PROJECT NAME:		GRASSI ADDITION PORTLAND, MAINE	
DRAWING NAME:		FLOOR PLAN	
SCALE:	1/4" = 1'-0"	DRAWN BY:	JEFF S. GIGGEY
DATE:	4/02/04	DWG. NO.:	102

FLOOR PLAN

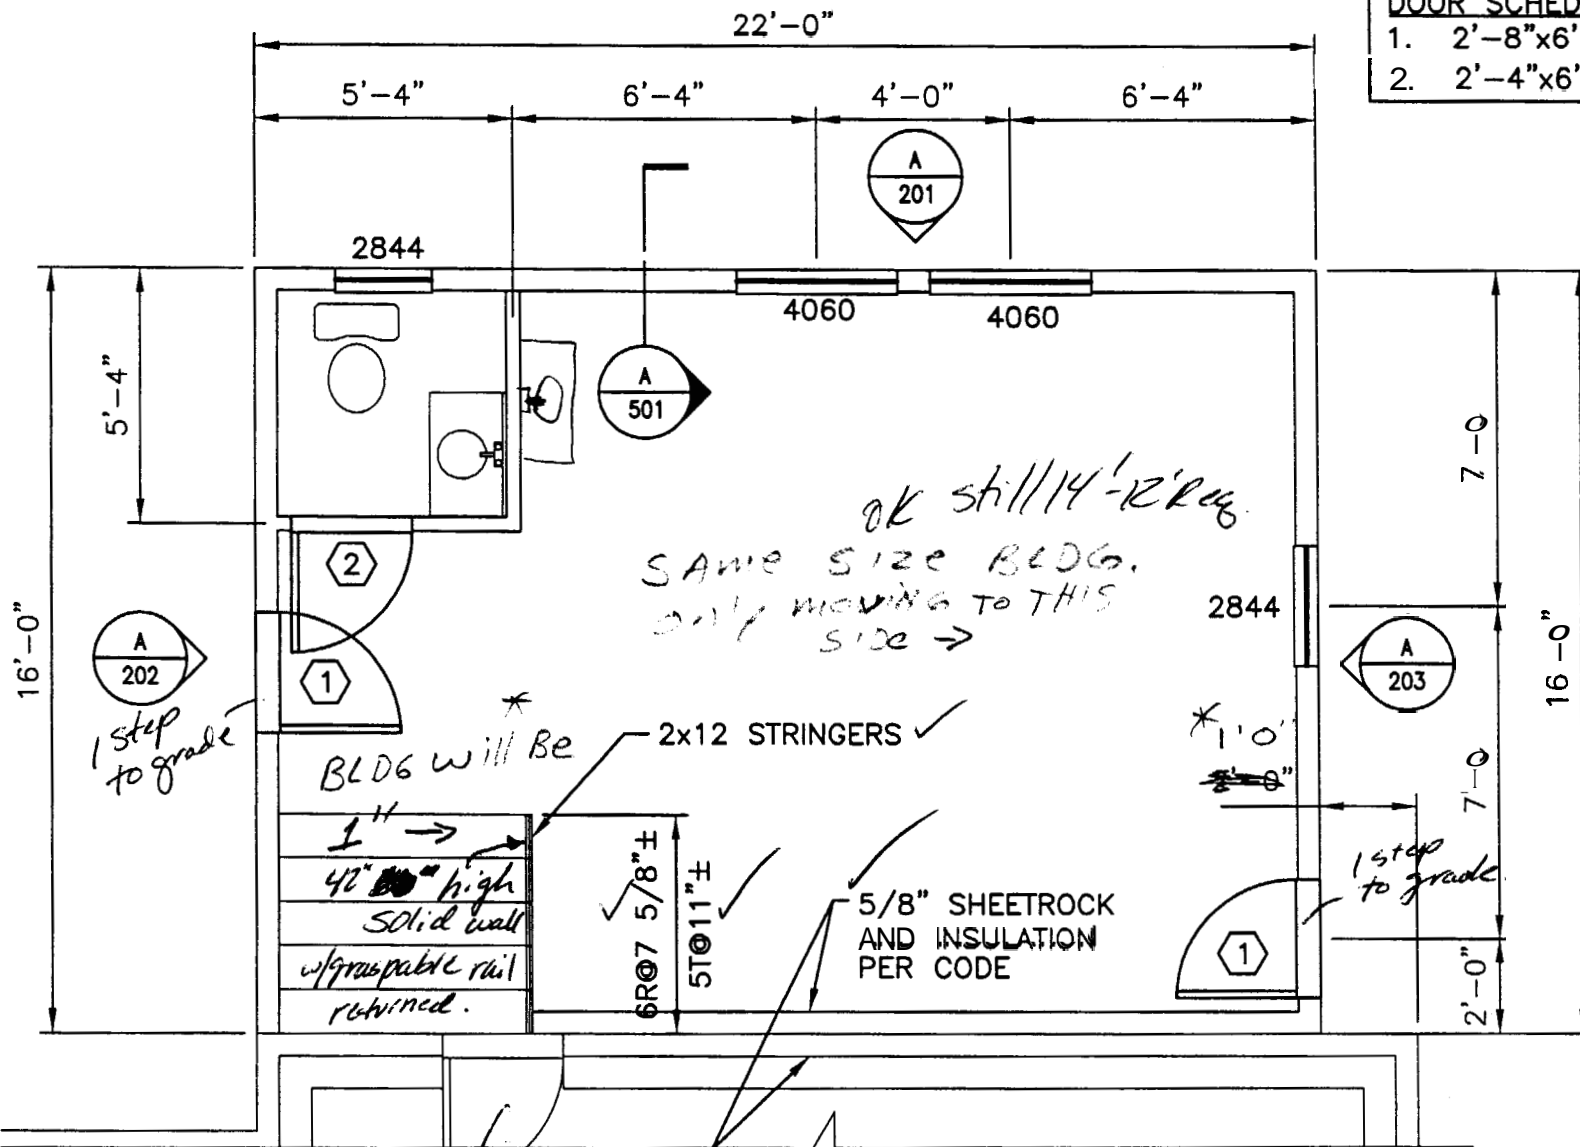
*OK still 14'-12" Reg.
 SAME SIZE BLDG.
 ONLY MOVING TO THIS
 SIDE →*

BLDG will be
 2x12 STRINGERS ✓
 1" →
 42" high
 SOLID WALL
 w/graspable rail
 returned.
 6R07 5/8" ±
 5T011" ±
 5/8" SHEETROCK
 AND INSULATION
 PER CODE

Rated door

REVISE
